APPENDIX J AVIATION ADVICE AND OBSTACLE LIGHTING PLAN

Re: Hills of Gold Wind Farm – AIA Response to Submissions and Amendment Report

Re: Review of CASA submission on obstacle lighting at Hills of Gold Wind Farm – obstacle lighting intensity

Figure 3 WTG Proximity to Crawney Pass National Park

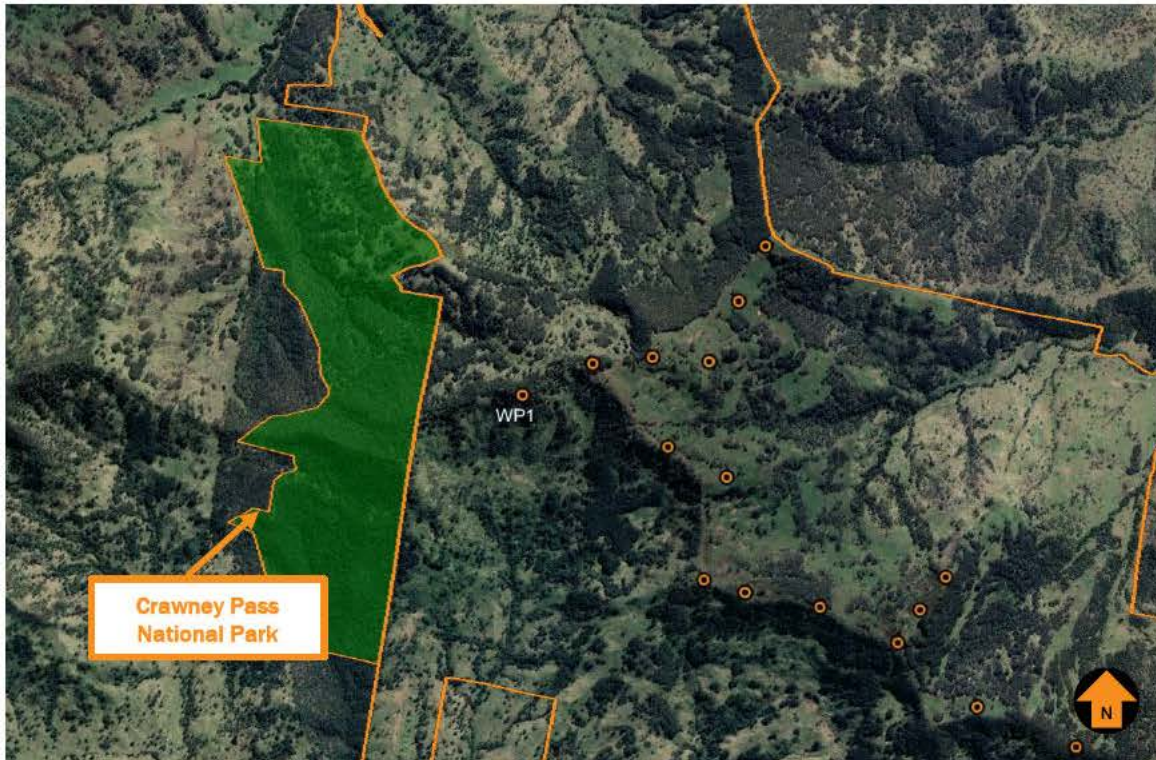
The closest WTG to the CPNP boundary is WP1 as shown in Figure 3. At the nearest point the WTG is located approximately 685 m from the national park. It is therefore unlikely that the proposed WTGs will have any significant adverse impacts on NPWS aerial operations.

Figure 4 WTG Proximity to Ben Halls Gap Nature Reserve

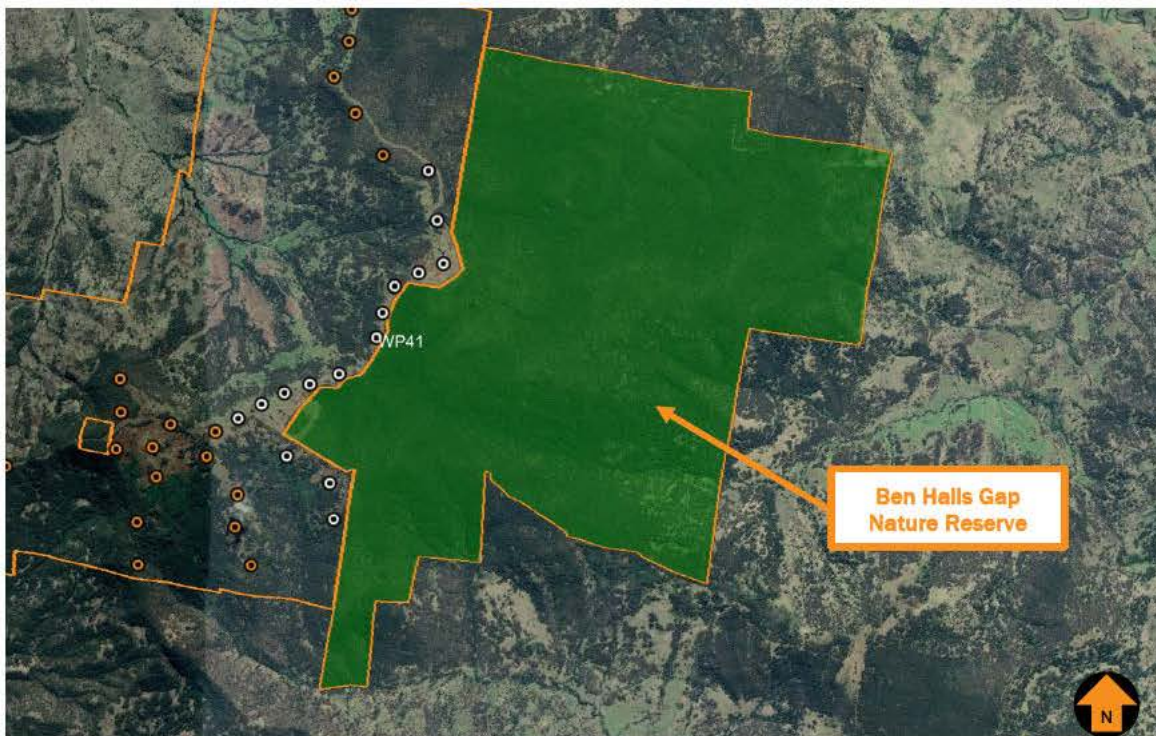
BHGNR and the Hills of Gold WF share a boundary on the eastern side of the Project area. 15 WTGs are planned to be located in close proximity to this shared boundary. Turbines will not be placed closer than 83.5m from the BHGNR boundary. This distance is similar to the extent of the largest rotor blades, therefore the blades will remain clear of BHGNR airspace when in operation. It may, however, affect where aircraft can fly in close proximity to the boundary. Other WTGs located along the site boundary are summarised in

Due to the proximity of the WTGs to the BHGMR boundary, there may be an impact on aerial operations within the BHGMR, and particularly when the WTGs are operating.

Aircraft may not be able to manoeuvre with the same freedom available now, and may have to reorient their flight paths to be able to achieve the same results in terms of deploying baits for pest control or surveying.

To minimise the potential adverse impacts and safety concerns on NPWS aerial operations, it is suggested that the Proponent engages with NPWS aerial operators to develop procedures, which may include, for example, stopping the rotation of the wind turbine rotor blades prior to the commencement of aircraft operations in close proximity to the western boundary of BHGMR.

To assist NPWS, the Proponent should provide the location and height of wind turbines and wind monitoring towers so that it may provide aerial application operators with all relevant information. This information, and a description of the infrastructure, should be provided in suitable GIS format prior to construction.

**HILLS OF GOLD WIND FARM –
SOUTHERN PORTION
OBSTACLE LIGHTING PLAN**

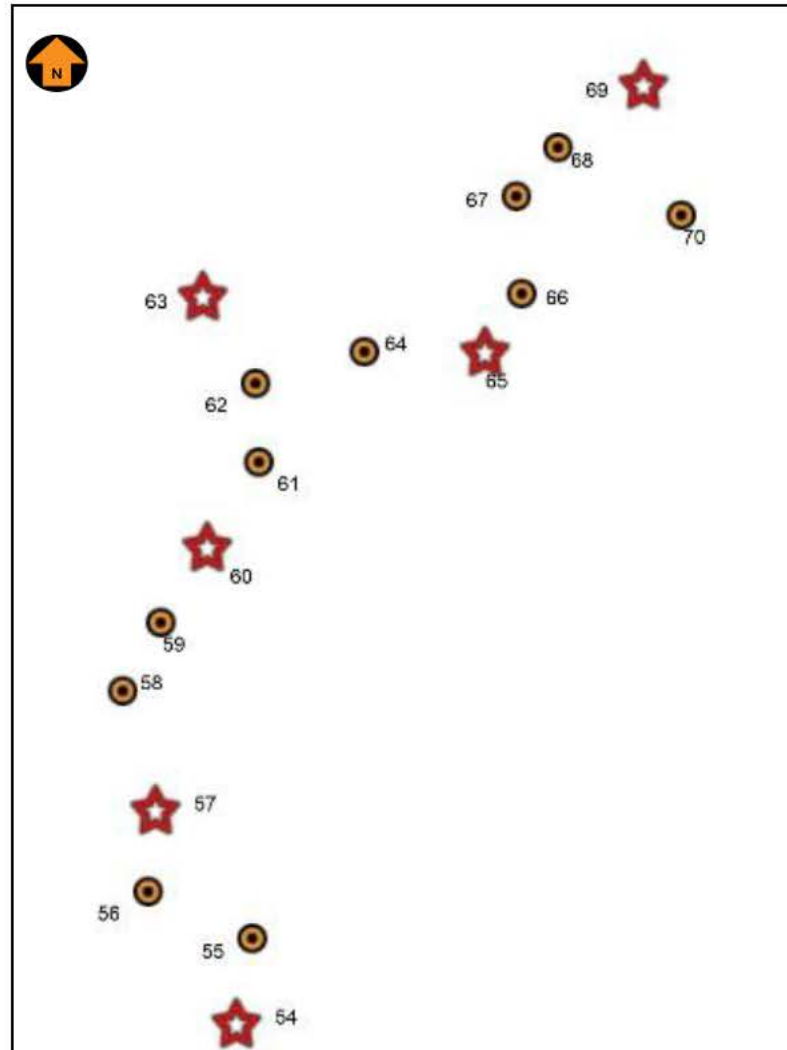
- 5 turbines have now been removed from the 70 turbine layout presented in the EIS.
- Visual impact of night time aviation obstruction lighting on the surrounding community is an important consideration for wind farms and is required to be assessed by NSW DPIE. The proposed lighting plan has sought to reduce these impacts as much as practicable whilst still providing an acceptable level of project lighting to the aviation industry. Turbines in the northern part of the project (T50 -> T70) have the highest potential for night lighting impact and thus the obstruction lights are fewer and have slightly greater spacing on these turbines.
- Despite the generally linear nature of the project, turbines on the extremities have been lit where possible.
- The lighting fixtures are nominated as low intensity with a minimum 200 cd intensity as per your earlier correspondence.

We would appreciate CASA's consideration and feedback regarding whether the proposed lighting plan in terms of those wind turbines identified for the installation of obstacle lighting would be acceptable.

After review, CASA accepts the lighting design and presented. I acknowledge that the spacings have been stretched marginally beyond those recommended in the NASF guidelines but agree that the final design will meet the intended outcome.
